HISTORIC AND DESIGN REVIEW COMMISSION

HDRC CASE NO: 2023-386
ADDRESS: 711 NAVARRO ST
LEGAL DESCRIPTION: NCB 408 BLK 15 LOT 1,2 3,4,5 & 6
ZONING: D, RIO-3
CITY COUNCIL DIST.: 1
APPLICANT: Alejandra Gutierrez/Aetna Sign Group
OWNER: LINDSEY LeJeune /Common Deck
TYPE OF WORK: Review of a master signage plan
APPLICATION RECEIVED: August 31, 2023
60-DAY REVIEW: October 30, 2023
CASE MANAGER: Edward Hall

The applicant is requesting a Certificate of Appropriateness for approval of a master signage plan at 711 Navarro. Within this request, the applicant has proposed the following:

EAST ELEVATION

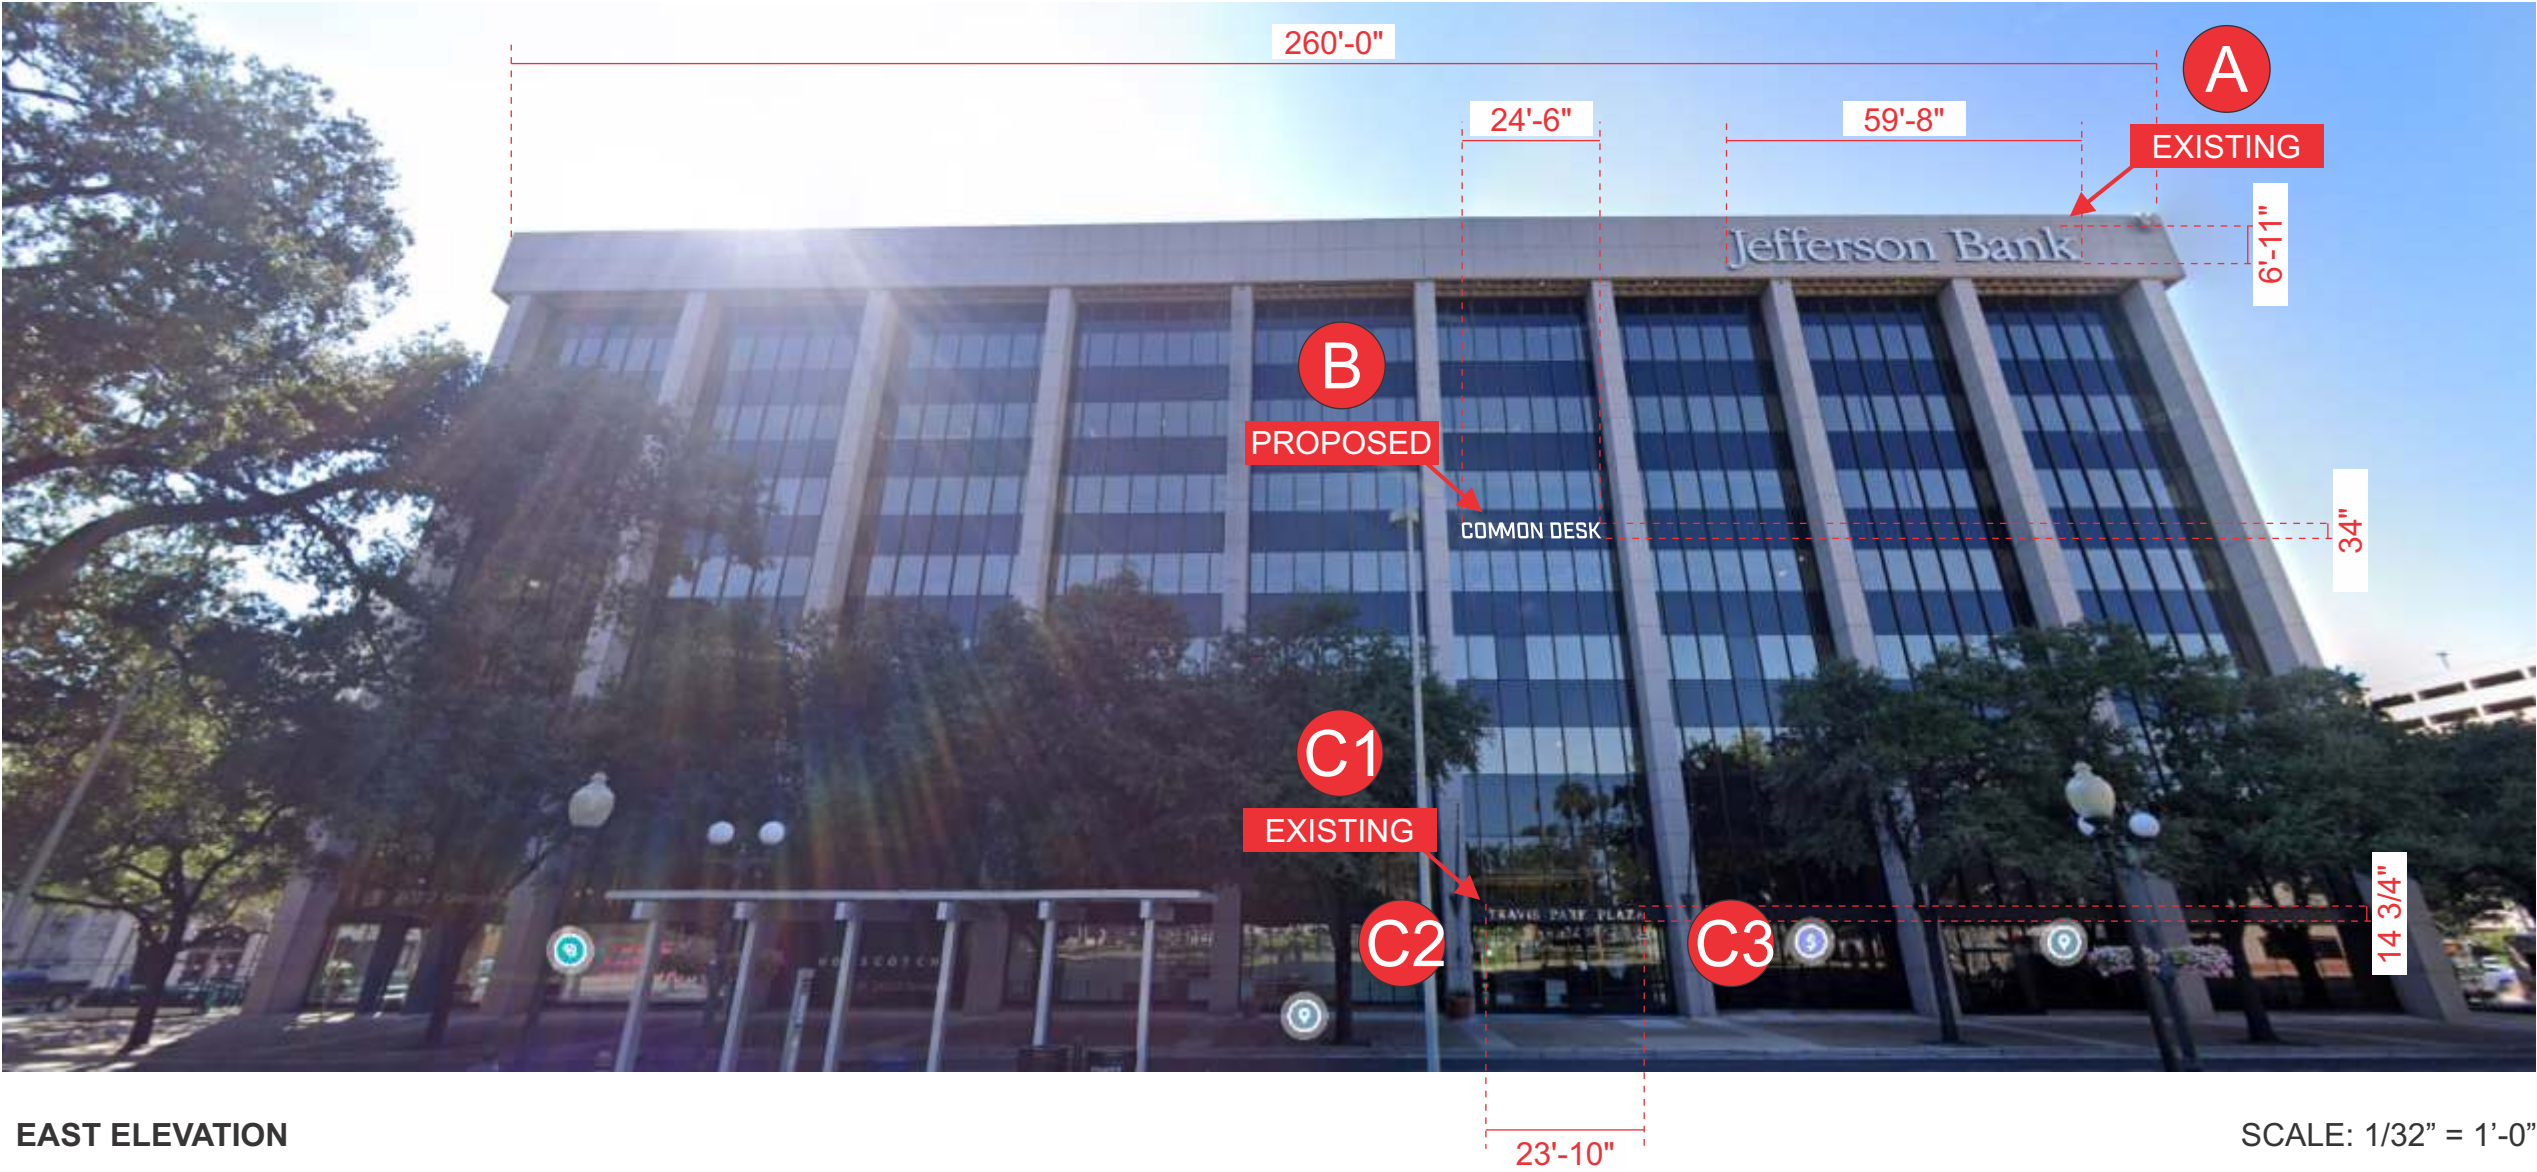
- f. WALL SIGN (East Façade, Cornice) – The applicant has proposed to install one, channel letter sign to be installed on the east façade at the building cornice. The proposed sign is to feature 24' – 0" in width and 11' – 2" in height for a total size of approximately 300 square feet. The proposed sign. This sign is identified as sign E in the application documents. The UDC Section 35-678(d) notes that signage width and height must be in proportion to the façade, respecting the seize, scale and mass of the façade, building height and rhythms and sizes of windows and door openings. Staff finds that the proposed signage should be reduced in width to be proportionate to the building's façade vertical façade bays.

3. Wall Sign (East Façade, Cornice): That the sign be reduced in width to be proportionate to the building's façade vertical façade bays. Final signage specifications, including materials, style and lighting are to match the existing and proposed channel letters on site.

Front View - Scale: 1/8"=1'-0"
70 SQ. FT.

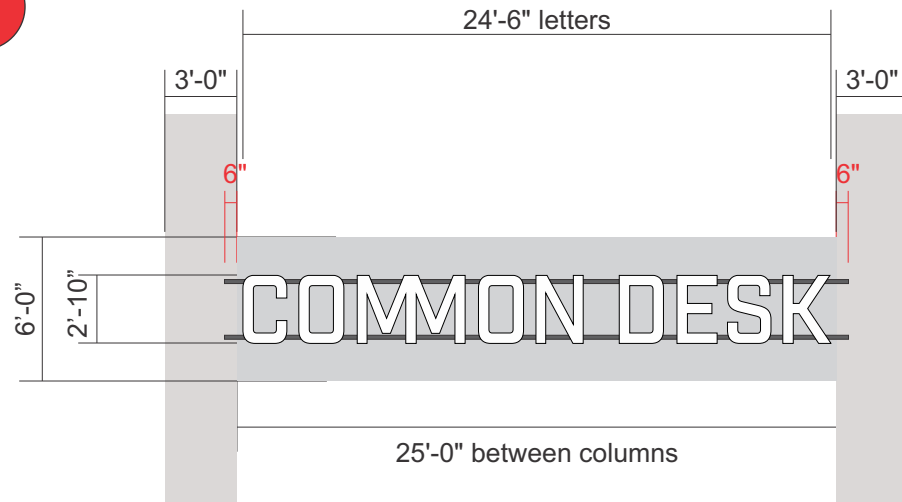
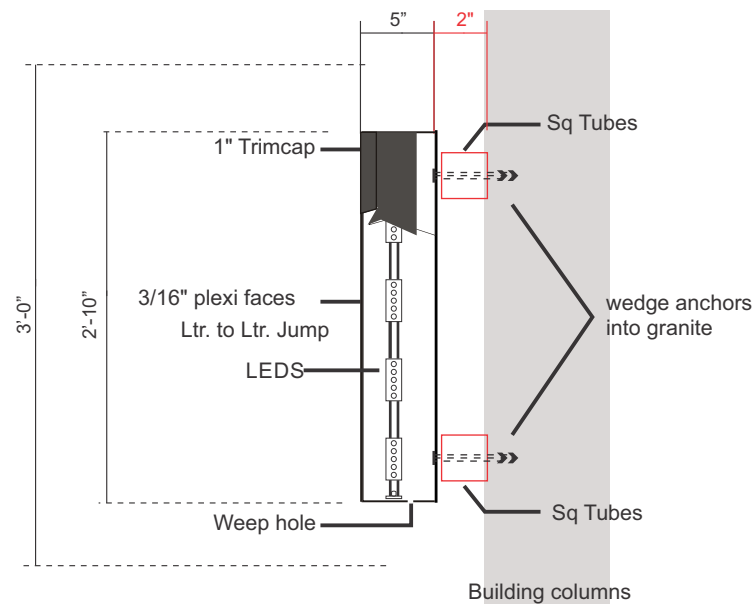
- d. WALL SIGN (East Façade) – The applicant has proposed to install one, channel letter sign to be installed on the east façade to feature 24' – 6" in width and 2' – 10" in height for a total size of seventy (70) square feet. The proposed sign will feature face lit channel letters on an aluminum backer panel. The proposed sign will be scaled to fit within an existing façade bay and will be located at the fourth level. This façade bay is immediately above the primary Navarro Street entrance. This sign is identified as sign B in the application documents. Generally, staff finds the proposed sign's placement and design to be appropriate and consistent with the UDC. A glare should not be produced by the proposed illumination.

1. Wall Sign (East Façade): That the raceway feature colors to match the window mullion system and that the final illumination not product a glare.
2. Wall Sign (South Façade, Cornice): That the sign be reduced in width to be proportionate to the building's façade vertical façade bays. Final signage specifications, including materials, style and lighting are to match the existing and proposed channel letters on site.

SOUTH ELEVATION SCALE: 1/32" = 1'-0"

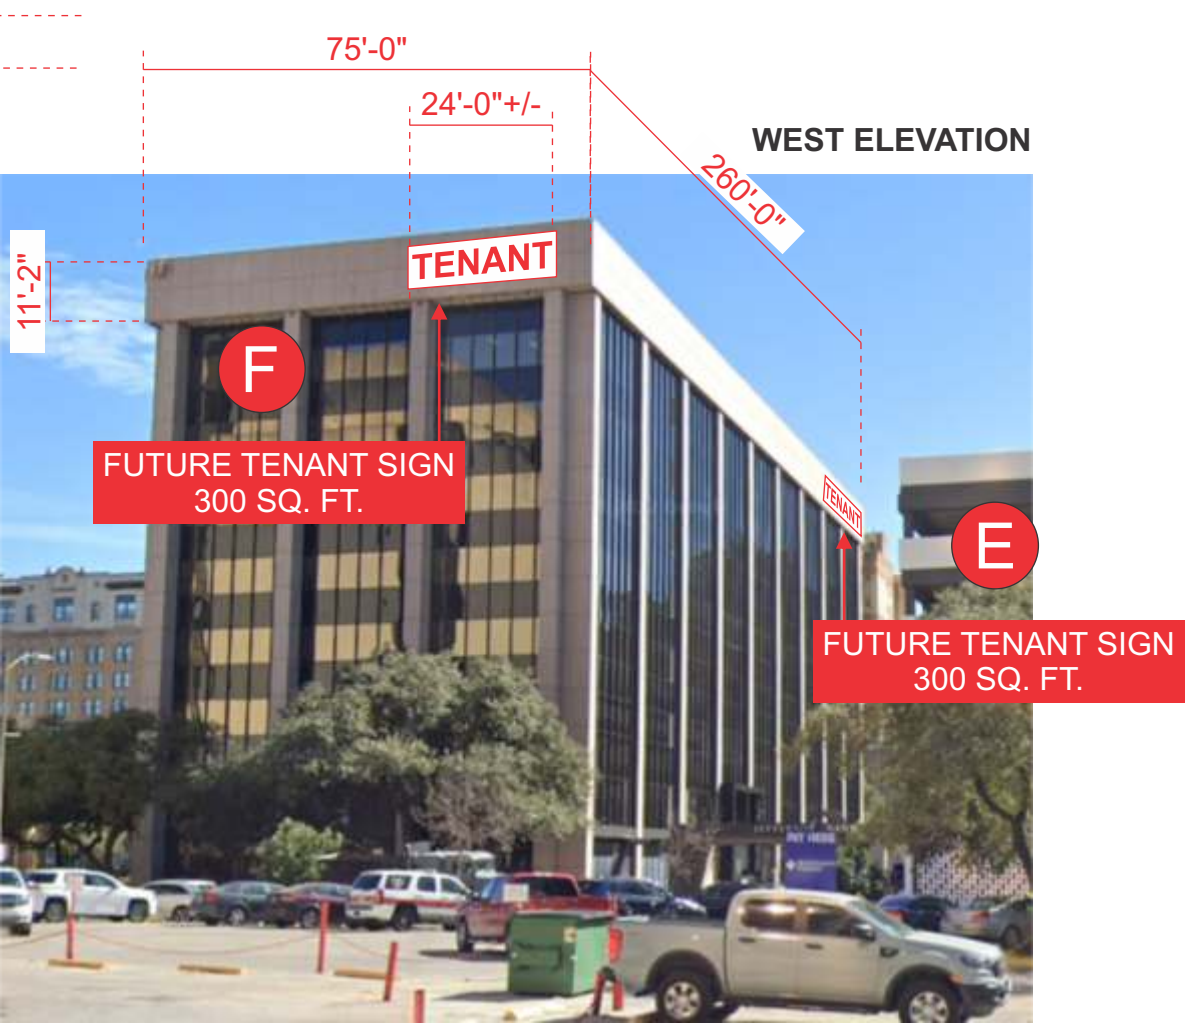
- e. WALL SIGN (South Façade, Cornice) – The applicant has proposed to install one, channel letter sign to be installed on the south façade at the building cornice. The proposed sign is to feature 24' – 0" in width and 11' – 2" in height for a total size of approximately 300 square feet. This sign is identified as sign D in the application documents. The UDC Section 35-678(d) notes that signage width and height must be in proportion to the façade, respecting the seize, scale and mass of the façade, building height and rhythms and sizes of windows and door openings. Staff finds that the proposed signage should be reduced in width to be proportionate to the building's façade vertical façade bays.

- g. WALL SIGN (North Façade, Cornice) – The applicant has proposed to install one, channel letter sign to be installed on the north façade at the building cornice. The proposed sign is to feature 24' – 0" in width and 11' – 2" in height for a total size of approximately 300 square feet. This sign is identified as sign F in the application documents. The UDC Section 35-678(d) notes that signage width and height must be in proportion to the façade, respecting the seize, scale and mass of the façade, building height and rhythms and sizes of windows and door openings. Staff finds that the proposed signage should be reduced in width to be proportionate to the building's façade vertical façade bays.

4. Wall Sign (North Façade, Cornice): That the sign be reduced in width to be proportionate to the building's façade vertical façade bays. Final signage specifications, including materials, style and lighting are to match the existing and proposed channel letters on site.
